**Manatee County Solid Waste Management Facility
Lena Road Class I Landfill
3333 Lena Road, Bradenton, Florida 34211**

**APPLICATION AND ENGINEERING REPORT FOR
RENEWAL OF THE CLASS I LANDFILL
OPERATION PERMIT**

RE: Lena Road Class I Landfill Operation Permit Renewal
Pending Permit No.: 39884-018-SO/01, Manatee County
WACS ID No.: SWD-41-44795

MANATEE COUNTY LENA ROAD LANDFILL STAGES I, II AND III PHOTOGRAPH

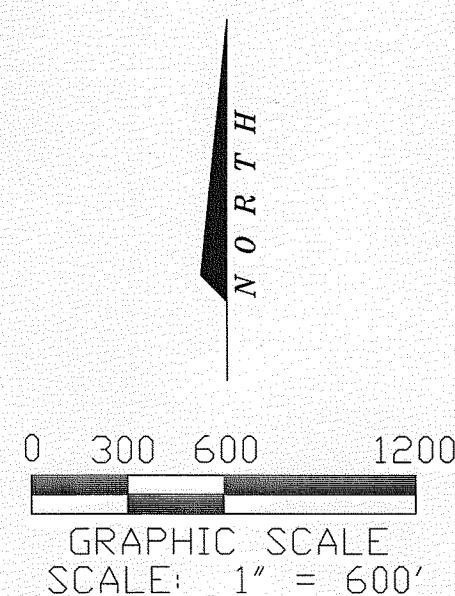
7. **Section F-1 and Figure E-1 (aerial photograph):** As a result of the recent eastern expansion of Stage 3 and the relocation of the administrative offices, HHW facility, and citizen drop-off area, the aerial photograph provided, although less than 1 year old, appears to no longer be representative of the current conditions at the facility. Please verify and provide a more current aerial photograph of the facility.

23. **Sheet C-2:** Please provide a more current aerial of the facility that shows the current conditions at the facility (See Comment #7, above).

Response: Sheet C-2 was revised to include the 2010 aerial photograph.

TOPOGRAPHIC SURVEY

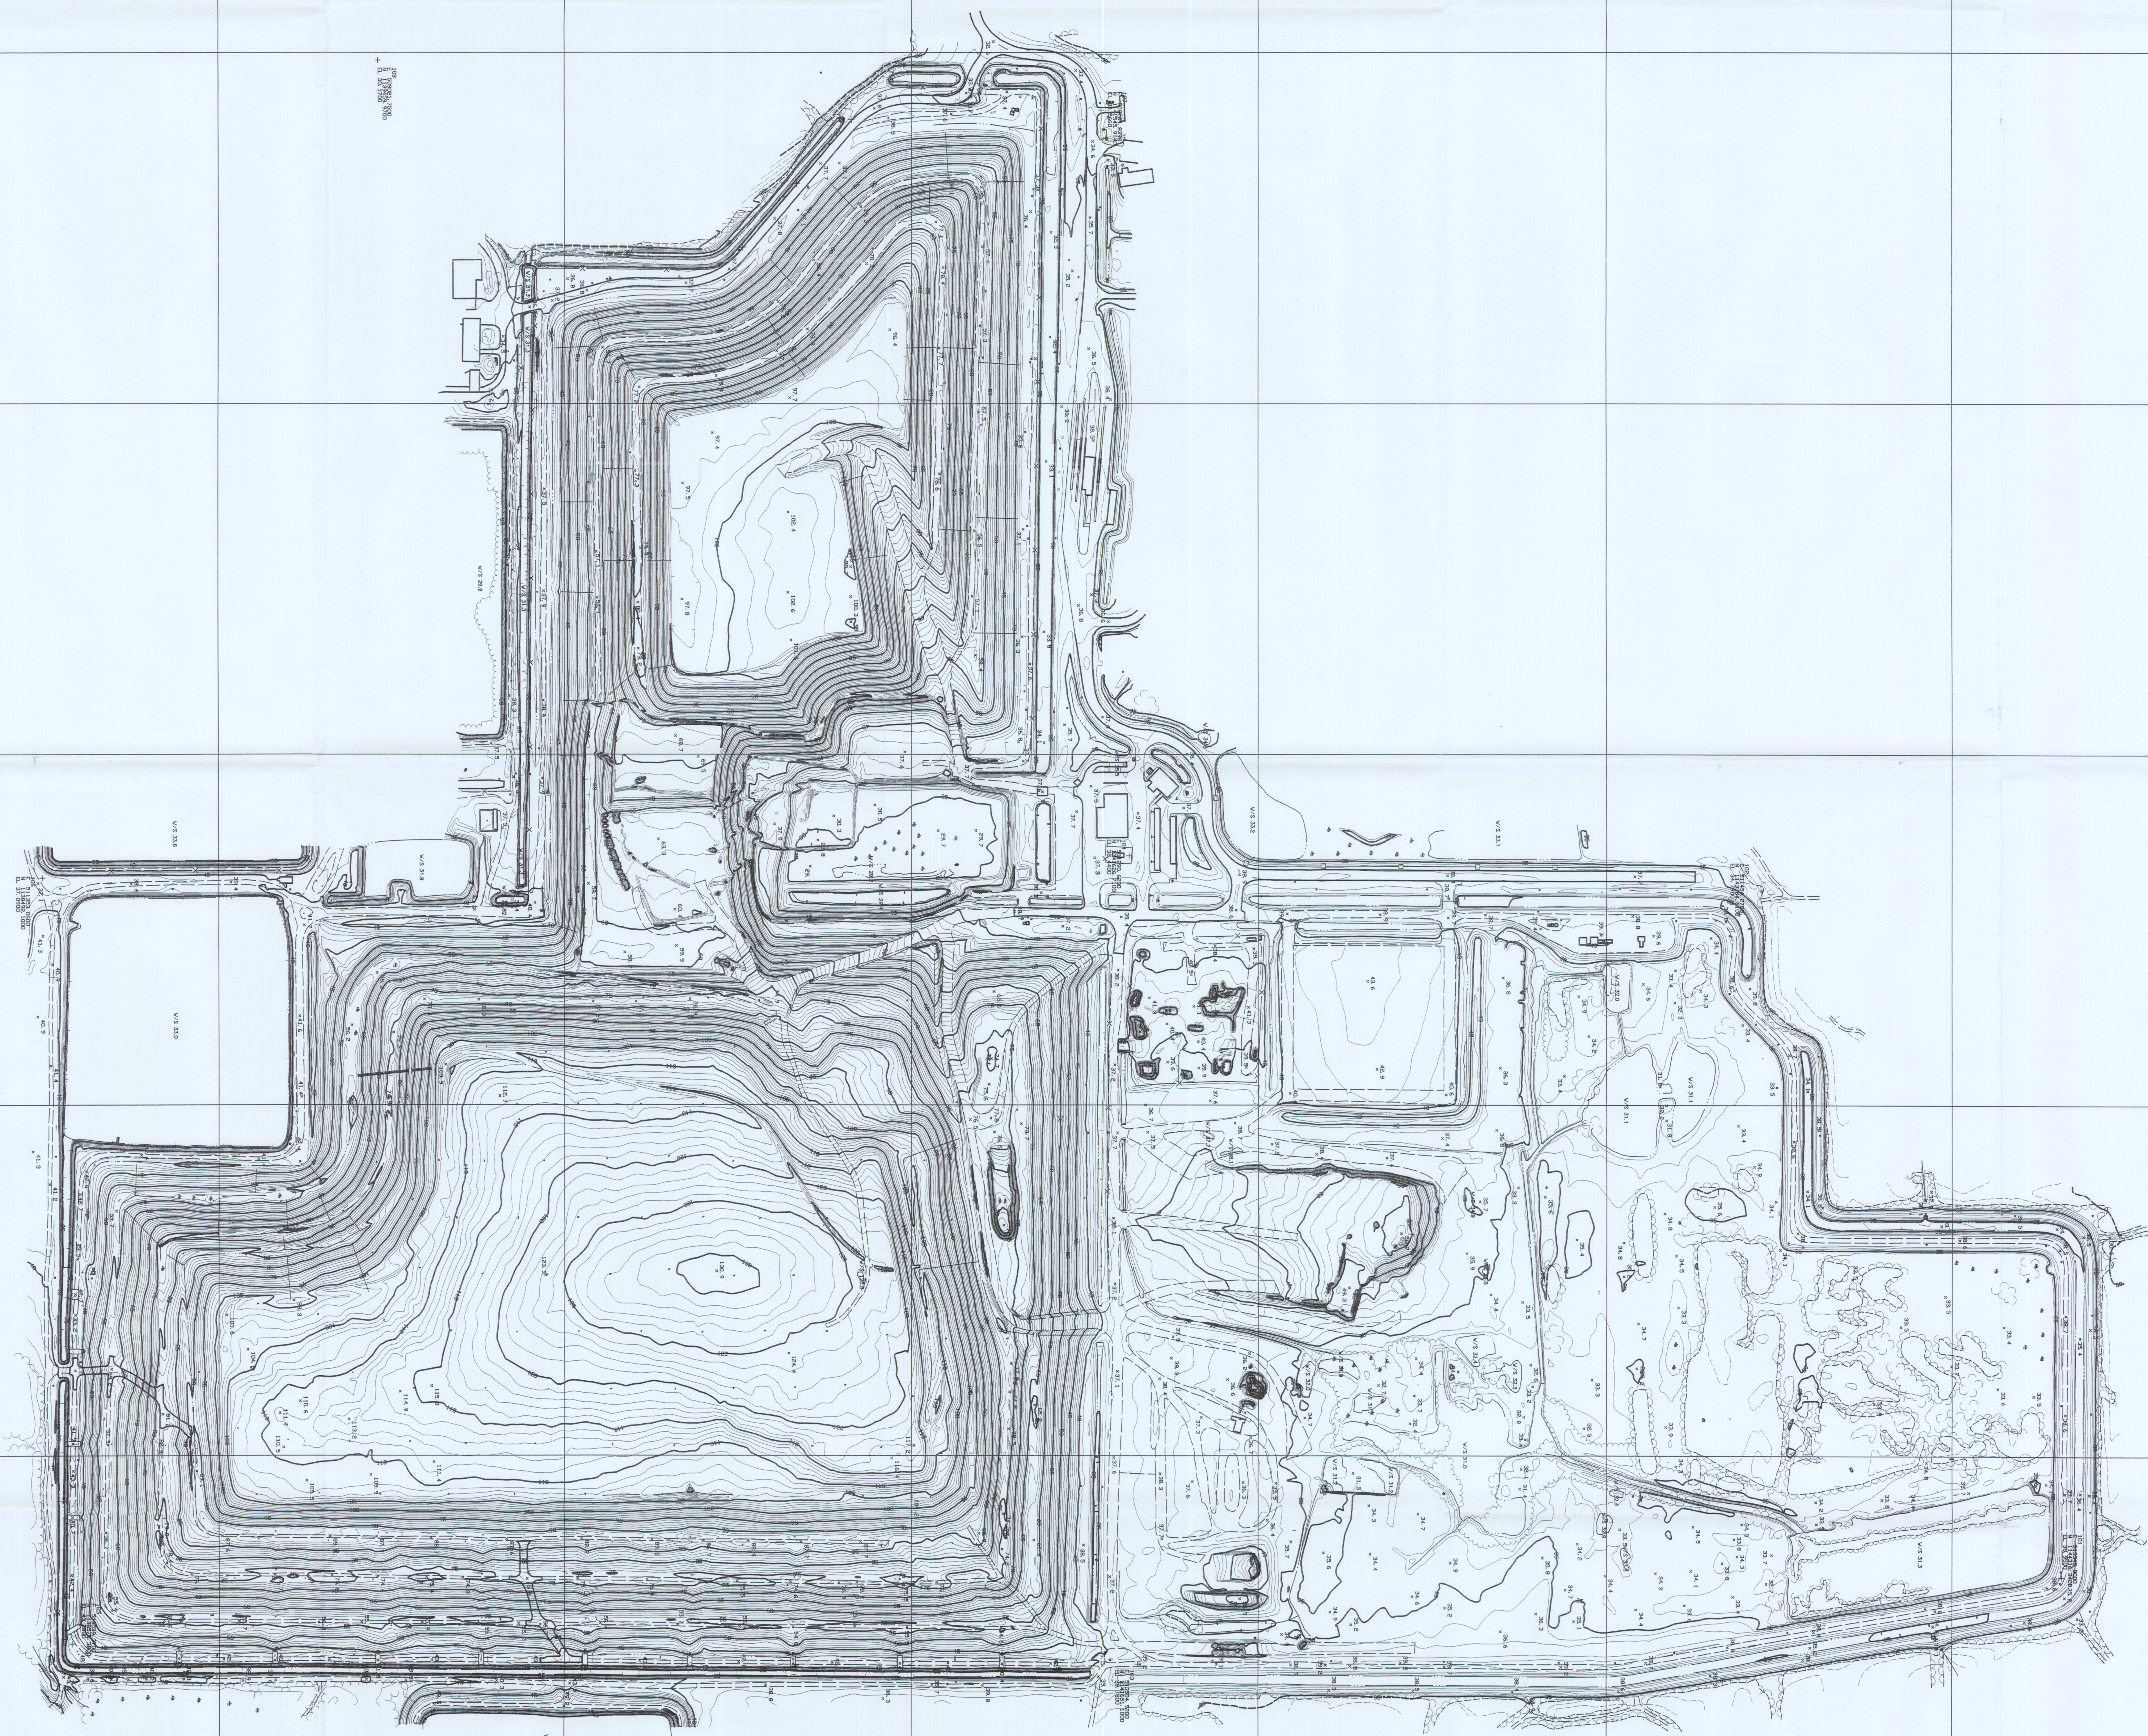
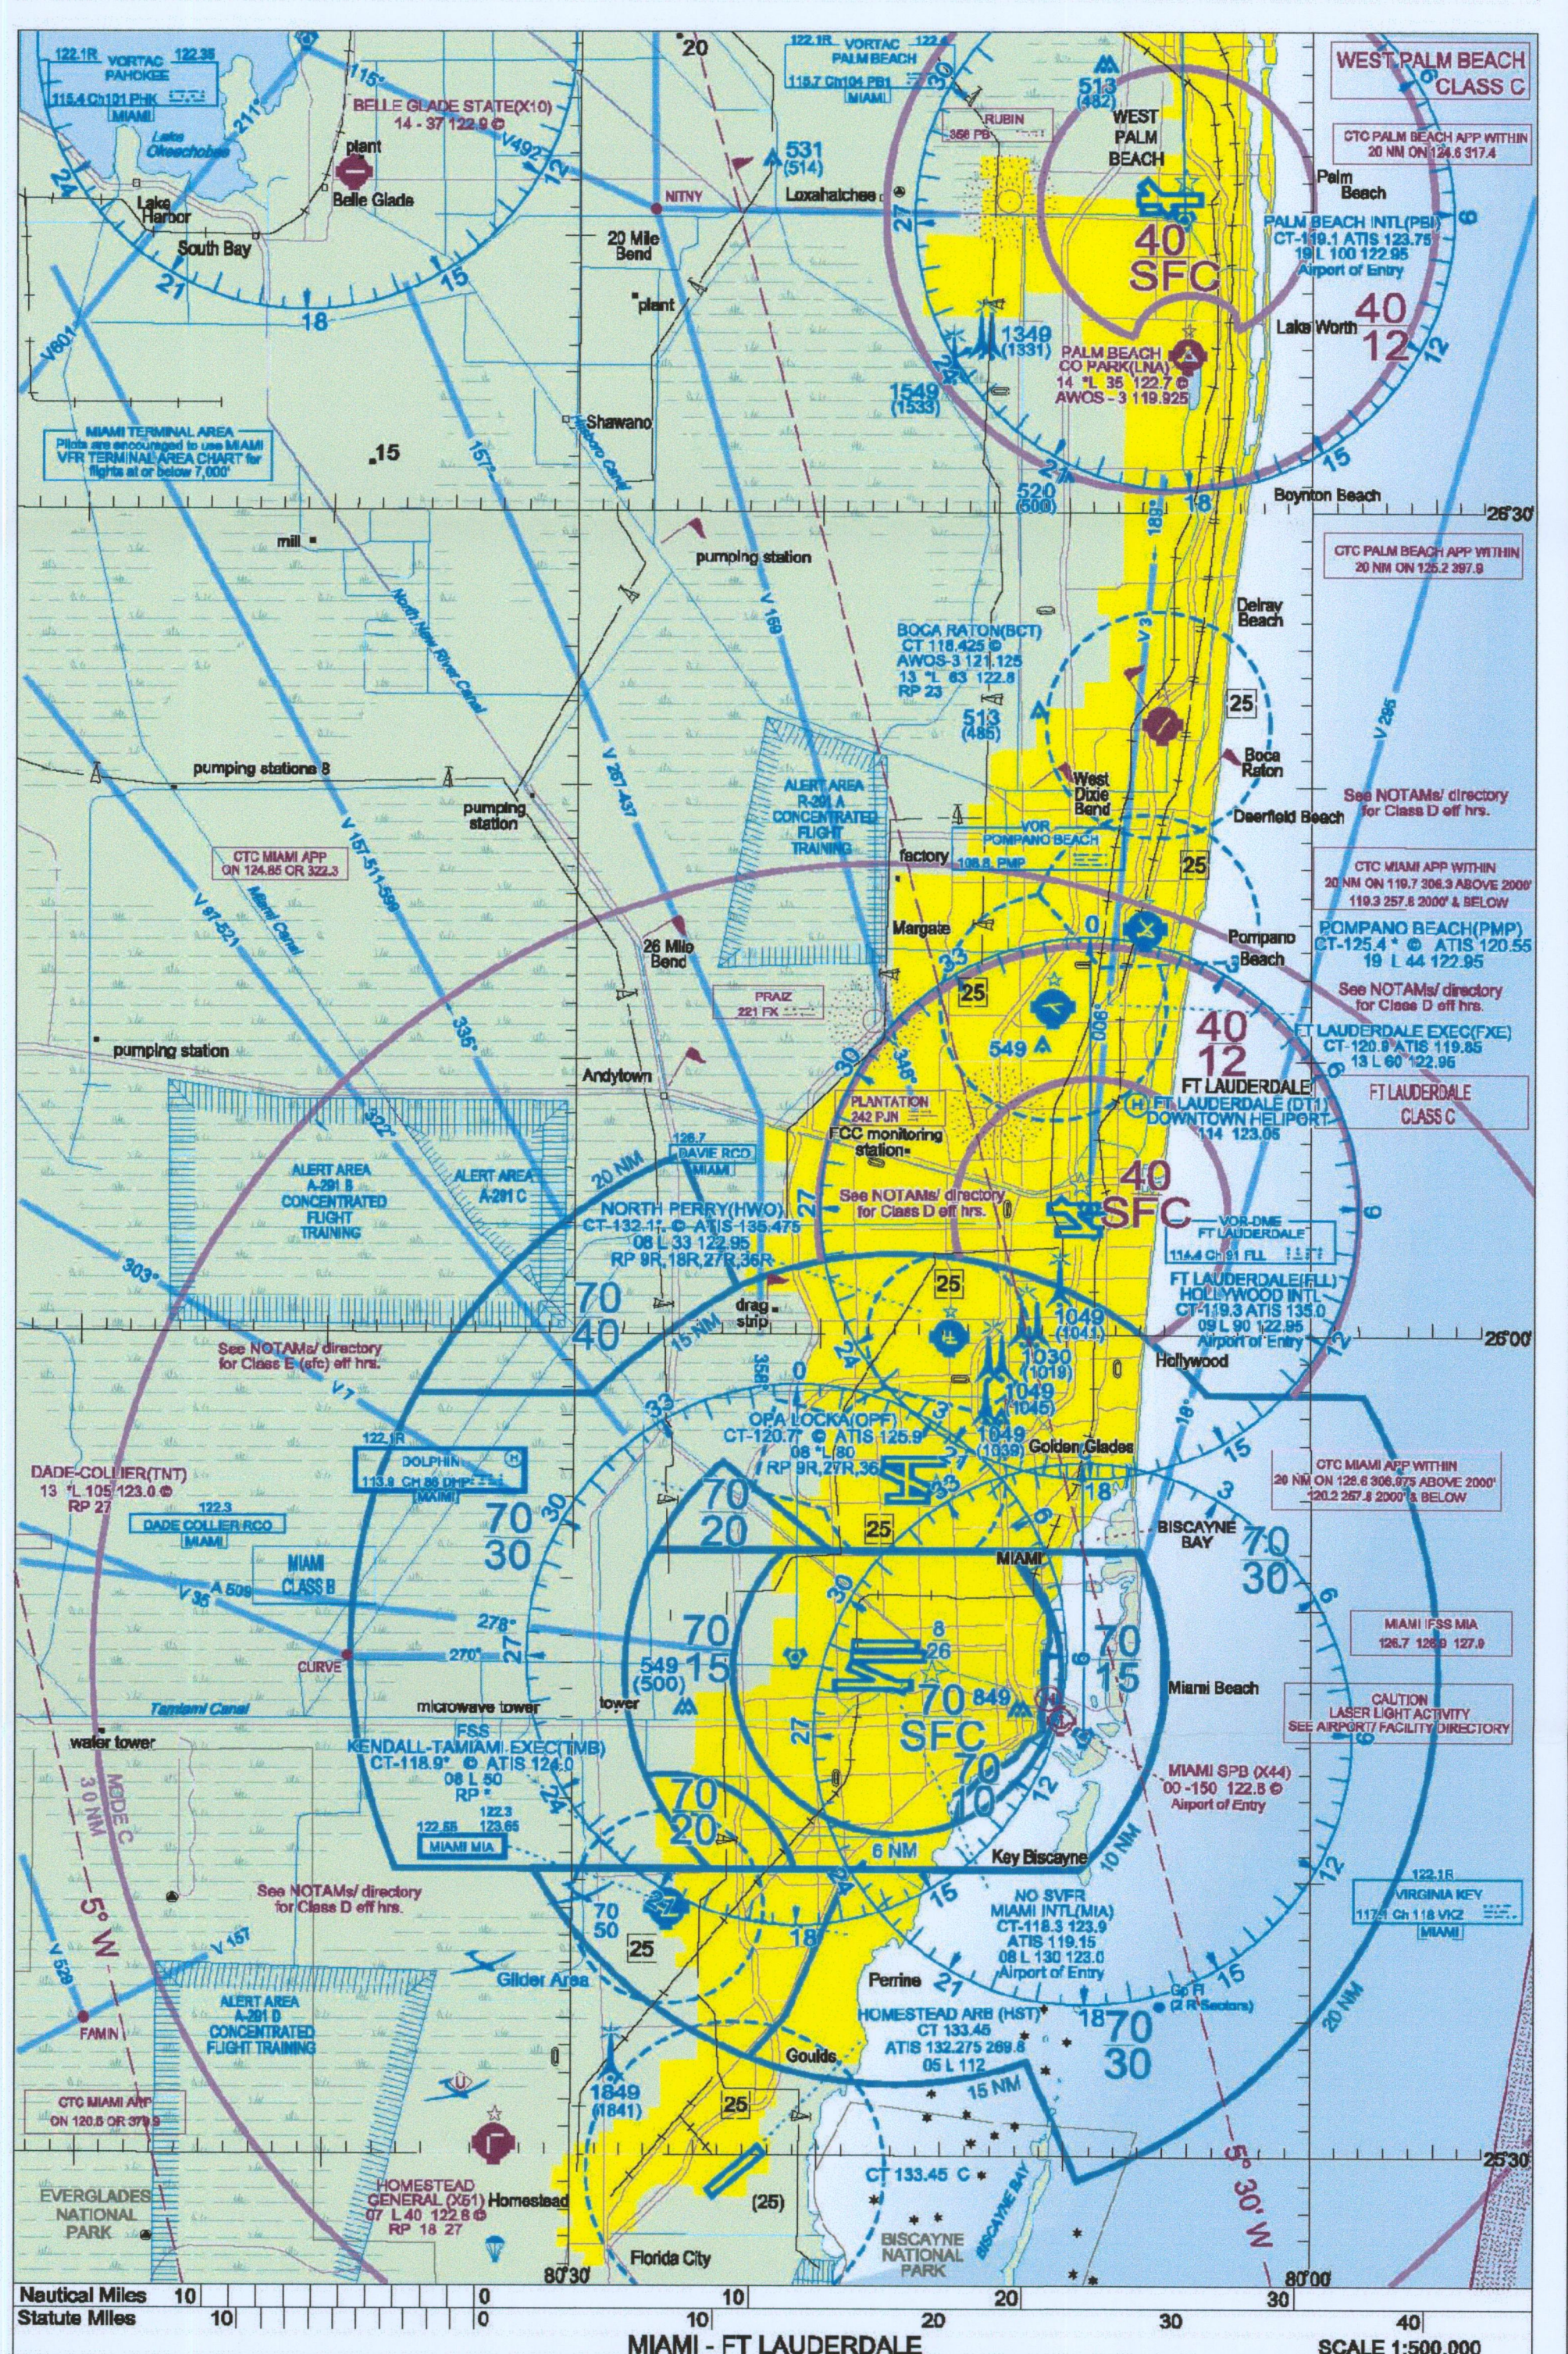
24. **Sheet C-3:** Please provide a copy of the topographic survey of the facility signed and certified by the professional surveyor that prepared the survey.

Response: Sheet C-3 was revised to include the topography from the 2010 aerial photograph. A copy of the topography signed and sealed was included with this response.
